# Dry Creek Watershed Plan Update

## Design Memorandum

RE: Dry Creek Watershed Plan Update

**Project Name and Number:** 29001 Dry Creek Watershed Project  
**Client Name:** Civil Engineering Solutions, Inc.  
**Contact Person:** Thomas Plummer, Jr., P.E.  
**Email Address:** [Thomasplummer@civilsolutions.org](mailto:Thomasplummer@civilsolutions.org)  
**Phone Number:** (916) 563-7300      **Fax:** (916) 563-7362

Exhibit 1

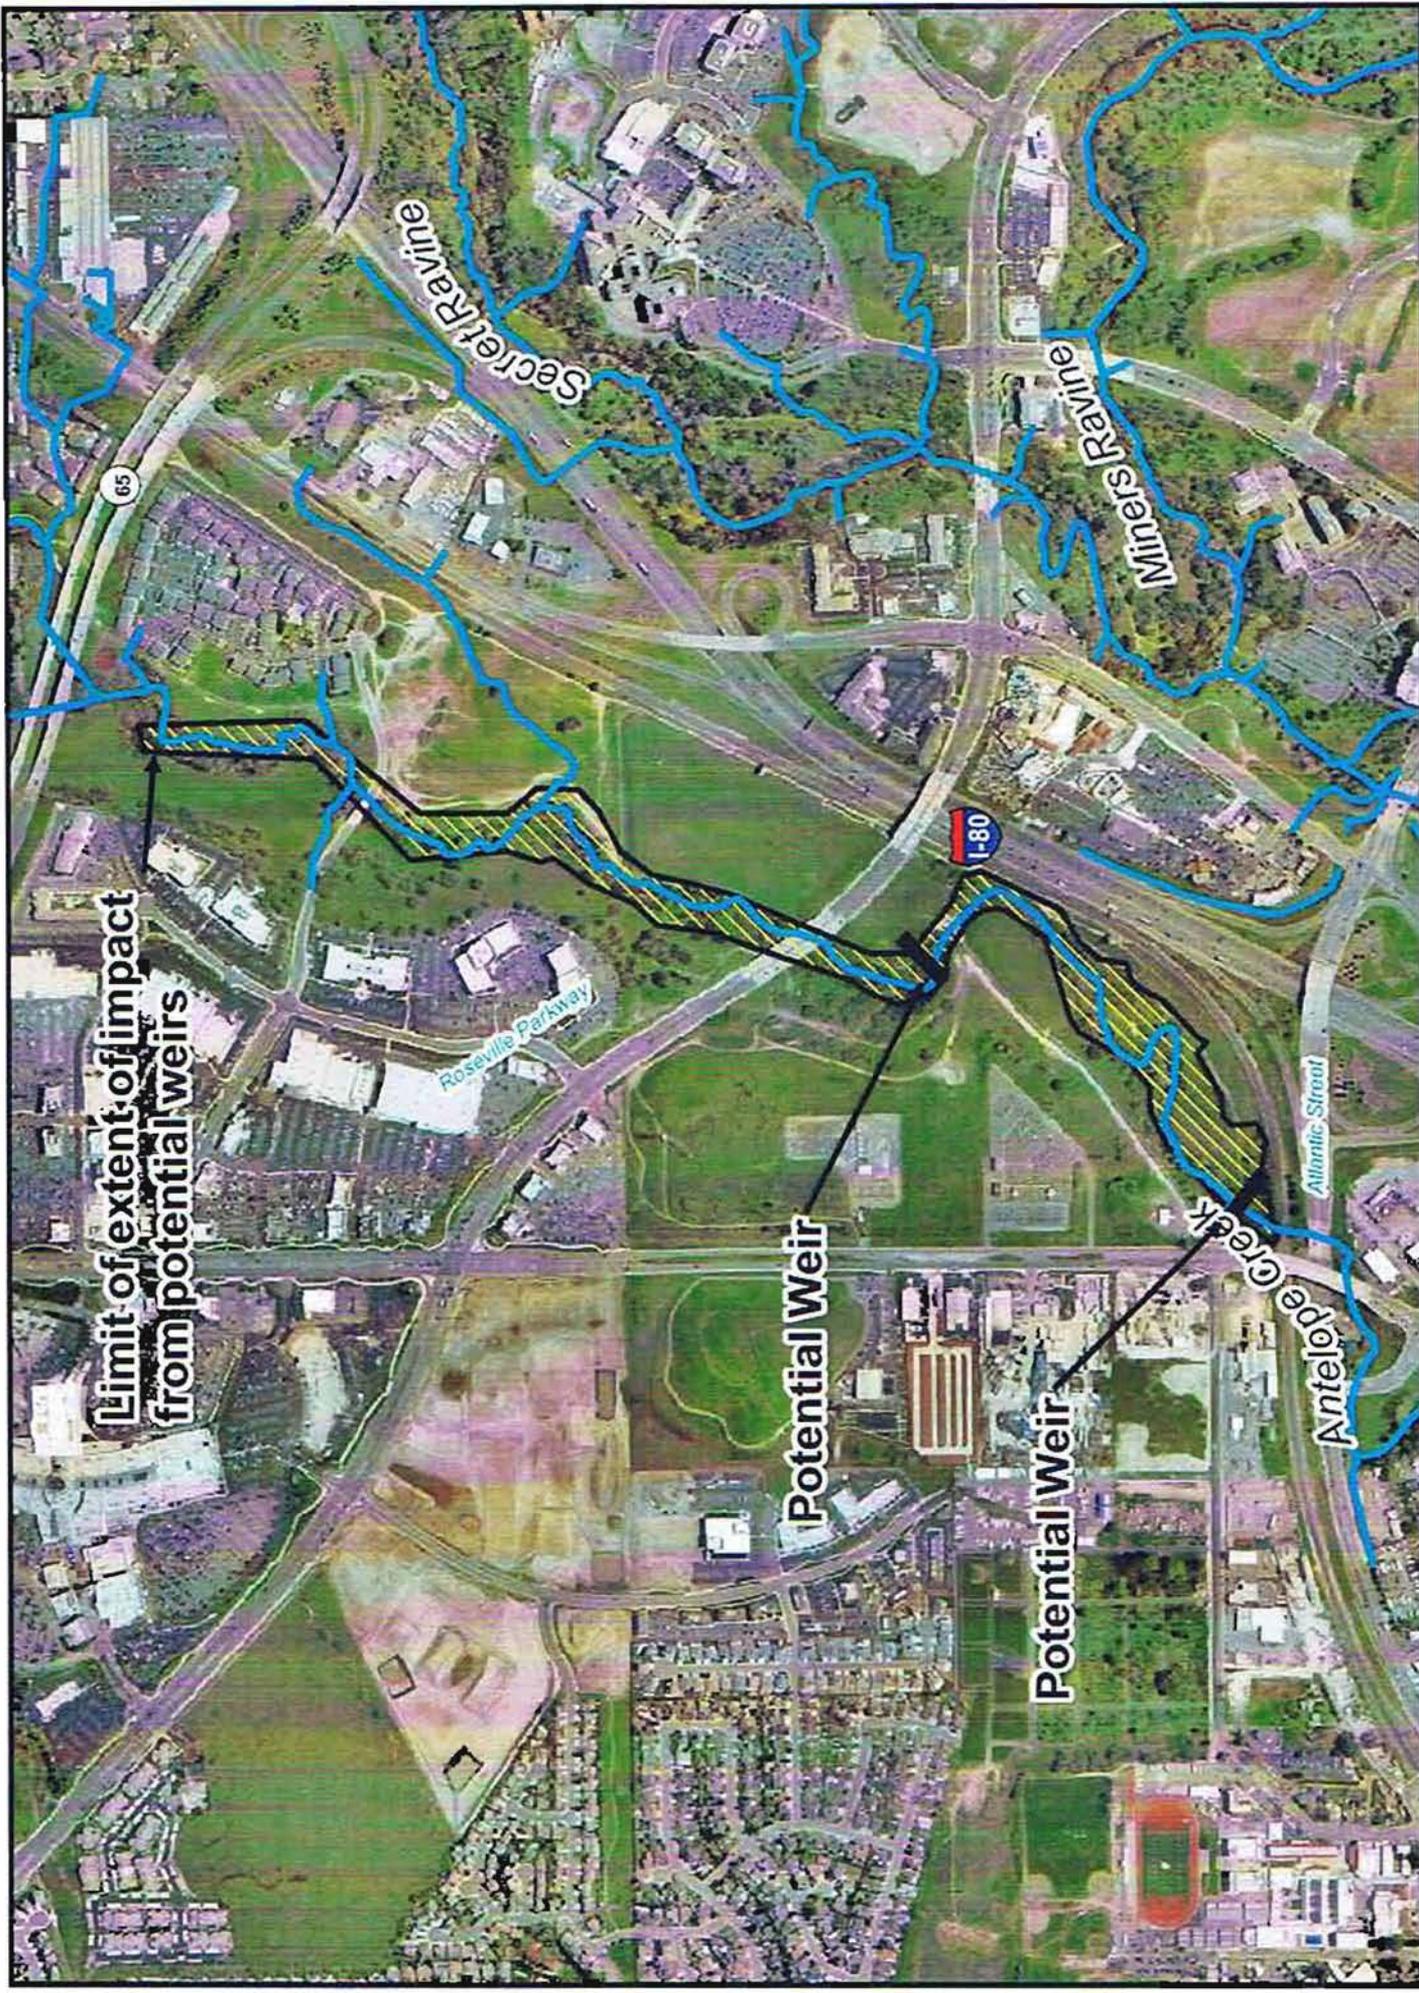
*Site Constraints:* The proposed location for Weir #1 is constrained by an existing underground gas line and a sewer line. We believe that the location of the weir should be moved upstream of the gas line and sewer line access manhole and downstream of the existing storm drain outfall bringing runoff from the base of the railroad grade and adjacent capped landfill site to Antelope Creek. The weir should tie into the existing berm covering the sewer line and be constructed in a manner to allow room on the downstream side of the proposed weir for access to the sewer line where it crosses under the creek or railroad grade for future maintenance needs. The weir should also be constructed so that the spillway elevation is below the sewer line elevation to avoid flooding into the manhole. On the downstream side of the proposed weir we recommend that the earthen fill covering the existing gas line be provided with rock armor over geotextile fabric to provide erosion protection from peak flows, especially those that overtop the proposed weir. The existing maintenance road for the sewer line and landfill site could provide excellent all weather vehicular access to the weir for construction and on-going maintenance operations.

*Site Constraints:* The proposed location for Weir #2 across Antelope Creek appears to be upstream of the existing service road overcrossing and approximately at or near the location of an existing stream monitoring gage. This location is problematic for two primary reasons. First, construction of the weir at the proposed location would have significant impacts to well developed stream-zone waters of the U.S. and wetlands along with valuable riparian habitat components up and downstream of the weir which developed as a result of beavers damming the stream at the service road overcrossing. And second, much of the work would necessarily be in the water and mucky sediment accumulated on the bottom of the beaver pond and a small willow-covered island would have to be removed, raising the cost of the venture.

**Opportunities & Constraints**  
 Dry Creek Watershed  
 Placer County, CA  
 July 30, 2010

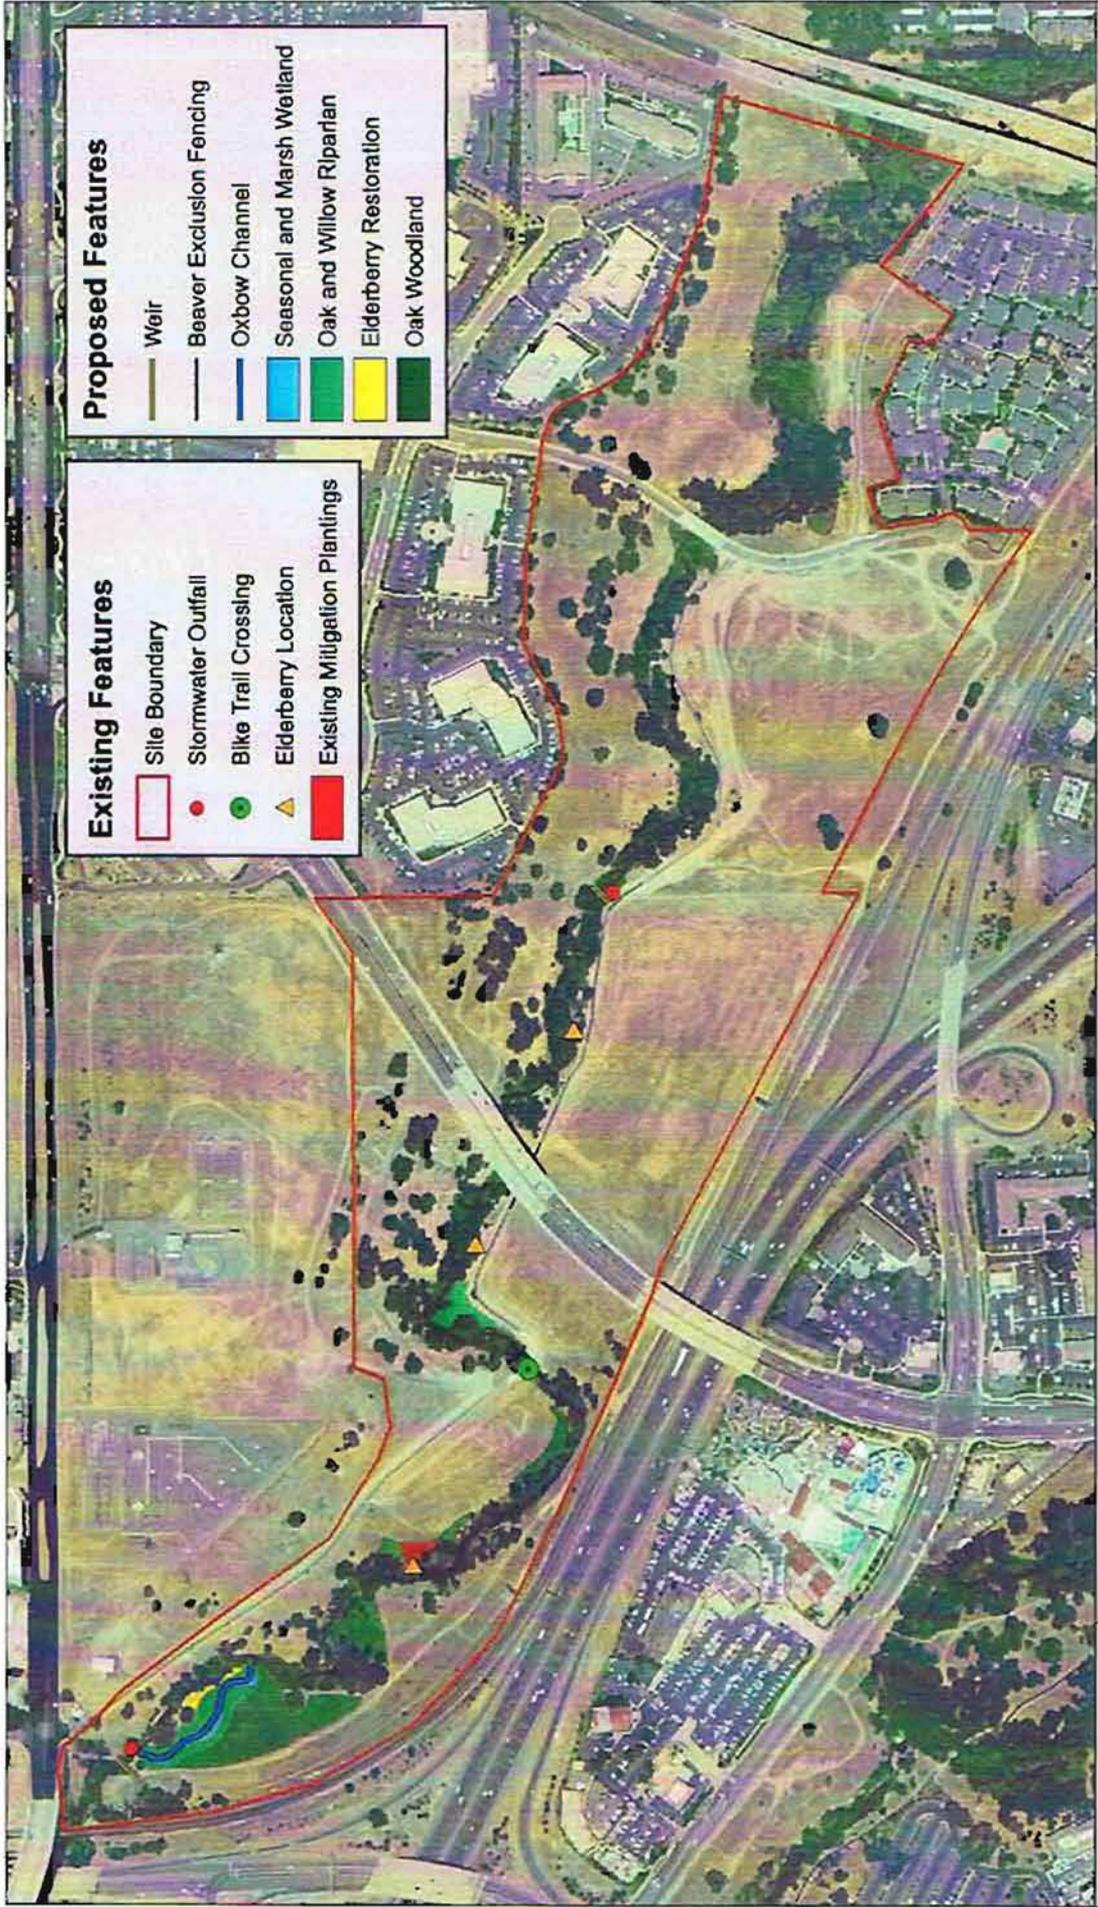
Site A: Large valley oak within the flood zone. Attention should be given to weir design and duration of flood up to prevent detriment to existing protected vegetation.

Site A: Parrots feather and concrete outfall. Noxious non-native vegetation should be treated and removed as part of the riparian enhancement.

Site A: Open Floodplain on downstream end of Antelope Creek. We suggest this site be used for wetland restoration ("Oxbow").

Site A: Existing Mounds of soil along Antelope Creek may be enhanced and created elsewhere on site to provide hydrologic/soil conditions for elderberry plantings.

Site A: Red sesbania. Noxious non-native vegetation should be treated and removed as part of the riparian enhancement.

Site A: Himalayan blackberry. Noxious non-native vegetation should be treated and removed as part of the riparian enhancement.

Site A: Bike trail crossing inlet. Pipes should be cleared and maintained. We suggest a beaver exclusion device be installed upstream of this location.

Site A: Bike trail crossing outlet. It is suggested that concrete slabs be removed and disposed of legally off site or used for upland habitat structures.

Site A: Oak tree mitigation plantation. There is a location on Antelope Creek that has been used for what seems to be oak tree mitigation plantings.

Site A: Oak tree mitigation plantation. Trees were planted in dense rows discouraging the development of a diverse and appropriately structured oak riparian woodland

Site A: Lower benches. Adjacent to the oak tree mitigation site at the base of the capped landfill there are sites suitable for additional oak plantings.

Site A: Lower benches. There are multiple locations along Antelope Creek at the base of the capped landfill that are suitable for oak tree mitigation plantings.

Exhibit 8  
Potential Project  
Secret Ravine upstream of Sierra College Boulevard

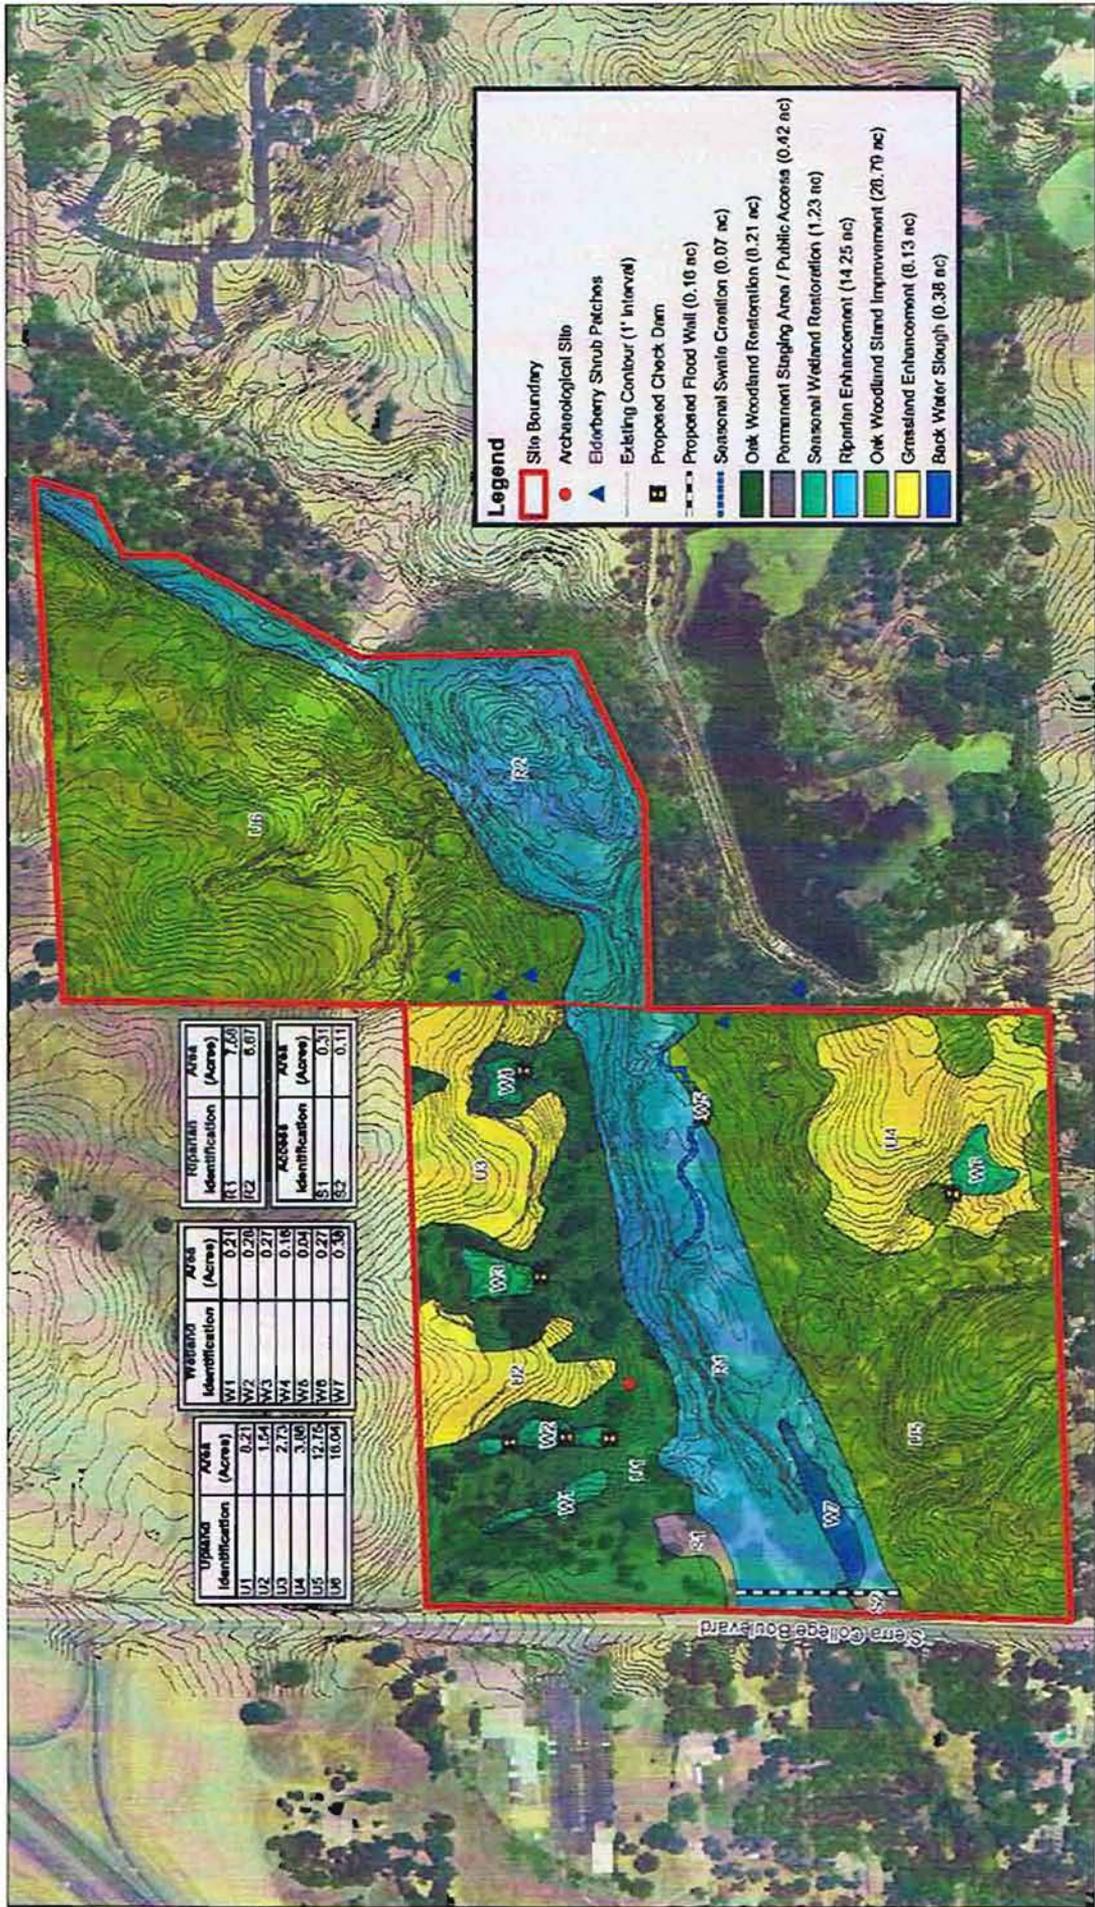
Data and maps provided to date indicate that a 300' long flood water detention wall spanning the Secret Ravine creek and its immediate floodplain will be constructed parallel to Sierra College Blvd. roughly 30 to 50 feet from the toe of the slope extending down from the elevated Sierra College Boulevard overcrossing. The conceptual plan indicates that the flood wall will have an opening presumably wide enough to pass the entire low flow volume of the creek and that the opening will span the existing creek channel. Flows in excess of the capacity of this opening will be detained upstream of the wall within the existing upper terrace floodplain. Our site inspection and preliminary vegetation analysis indicates that typical creek incision processes have left much of this upper floodplain terrace abandoned even during higher runoff events. The proposed project should re-attach the creek to much of the upper terrace floodplain area during peak flow periods while reducing downstream affects of flood waters on developed areas within the lower Dry Creek Watershed.

*Wetlands:* A map of biologic features identified by Jones & Stokes Associates (JSA) provided by our Client, indicated three potential vernal pool fairy shrimp habitat wetlands in the westerly portion of the site. We found the locations mapped by JSA and determined that two are in all likelihood not potential wetlands and certainly not fairy shrimp habitat. The third which is found north of and upslope from the creek between two mapped swales does support some typical vernal pool vegetation over an area of approximately 100 square feet. While it may well be delineated as a wetland, we would not expect this small isolated depression to support fairy shrimp. However, this depression should be avoided and protected during any construction activities thereby eliminating any need for very expensive vernal pool fairy shrimp habitat mitigation.

For the most part we agree with JSA’s depiction of other wetland features and sensitive habitats, the bulk of which are found along the creek and the easily identified swales. However, we located each of the mapped seasonal wetland features and found that the JSA map likely overstates their size and importance. The project will impact some waters of the U.S. and some riparian habitat at the weir construction site which will require mitigation. Therefore, a formal wetland delineation will be necessary for ACOE permit application. The flood zone resulting from the project is not likely to negatively affect any of the existing wetland features.
